Packet Guide
City of Charlottesville
Board of Architectural Review
Regular Meeting
May 19, 2026 5:30 p.m.
Hybrid Meeting (In-person at Council Chamber and virtual via Zoom)

Certificate of Appropriateness Application

BAR # 26-0017

Project: Accessibility project with site alterations

Existing

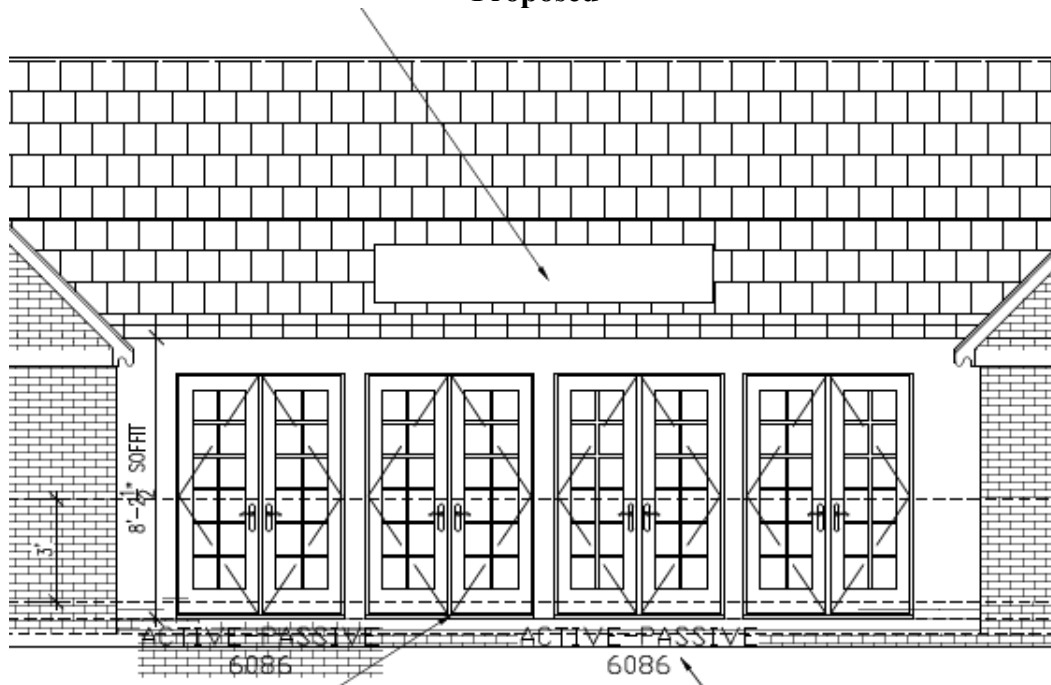
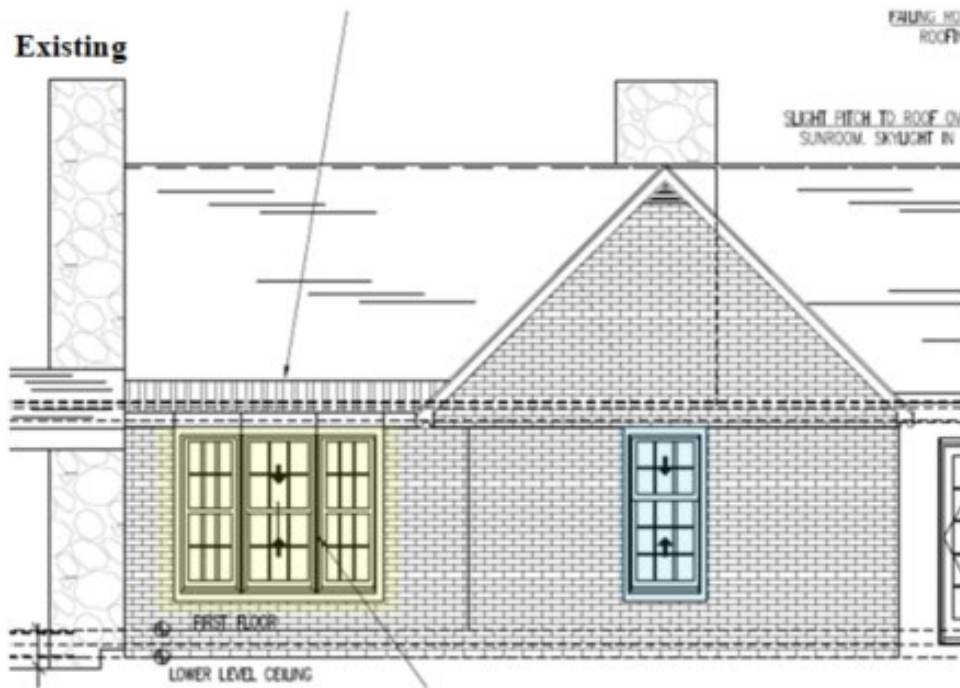
Rear elevation. Corresponding with infiltration mitigation and basement foundation repair, a new window will be installed where the bay window is currently located, and a sub-grade egress window installed for code compliance. A triple-framed window will replace the single window under the north rear gable.

At the sunroom, the existing series of rear doors are to be replaced. The skylight will be replaced, and the shingle roof replaced with EPDM.

Staff recommends approval of the door and window replacements, with a condition that insulated glass will have internal spacers bars aligned with applied grilles. BAR should discuss how to address the necessary brick infill at the two windows of the north wing. Should the infilled and/or repaired sections be flush with the existing wall or recessed slightly to indicate the alterations? With the bricks whitewashed, it is not necessary to match the brick color; however, the size and coursing should correspond with the existing, and new bricks should be toothed into the existing.
